# 17-072FDP – TUTTLE CROSSING MOTEL 6

Final Development Plan (FDP) for a three-story hotel and associated site improvements

A. Approval of FDP with four conditions

**East Elevation**

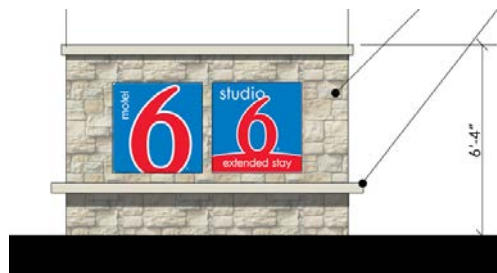
The applicant has revised the elevations to address the conditions listed in the August 24<sup>th</sup> staff report as well as the comments presented by the Commission. The proposed architecture consists of a three-story building in a rectangular shape with a hip style main roof mass and gable roof above the main entrance and accents along the northern and southern masses for both the east and west elevations. The proposed roof has retained the 6/12 pitch and adheres to the maximum height as measured by Code. The applicant has removed the two color schemes and is proposing earth tones colors for the materials, cultured stone and extending the stone to define the entrances on the east and south facades. The dumpster enclosure located in the northeast corner will use the proposed stone to complement the principal structure. The applicant is proposing to replace the previously proposed cedar siding with fiber cement siding retaining the 'Mahogany' color to provide accents for the upper stories. Staff is requiring that the applicant replace the 'Mahogany' fiber cement siding with the proposed stone to ensure a cohesive building design, prior to filing for building permitting.

- 1) That the applicant replace the 'Mahogany' fiber cement siding with the proposed stone, prior to filing for building permits;
- 2) That the applicant pay a tree replacement fee for outstanding caliper inches prior to filing for building permits;
- 3) That the applicant provide an updated photometric plan meeting the requirements of the development text with the building permit submittal; and,
- 4) That the applicant file an Amended Final Development Plan for the review and approval of the sign package.
